Discussion: Supply of COILS and ASSOCIATED PARTS FOR THE LASTI CONTROLS PROTOTYPES

Revision 00: 3rd November 2003 (RAJ, CIT)
 Revision 01: Comments in brackets following Weekly SUS Meeting on Tuesday 4th November
 Revision 02: Additional comments (RAJ, CIT)
 Revision 03: Comments: CIT to RAJ

The following is a summary of what is required in order to fulfill the order for the Local Control OSEM assemblies for the Advanced LIGO Controls Prototype Suspensions at LASTI. This document is intended as a source of discussion for the Weekly SUS Meeting on Tuesday 4th November, 2003.

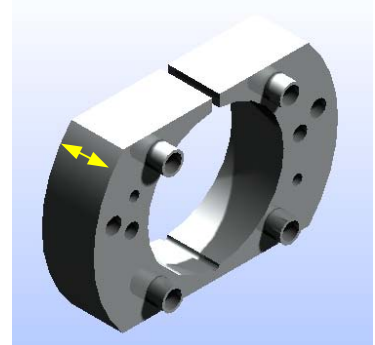
To the right is a rendered view of the COILFORMER CLAMP_ALT in which the thickness (as indicated in yellow) has been increased. Whether these ALT components are required (and if so, how many?) should be discussed.

Discussion: Supply of COILS and ASSOCIATED PARTS FOR THE LASTI CONTROLS PROTOTYPES*(ALT components chosen to provide additional stability to the assembly during adjustment)***BREAKDOWN OF QUANTITIES: as agreed at ALUK meeting in August 2003****Requirements:**
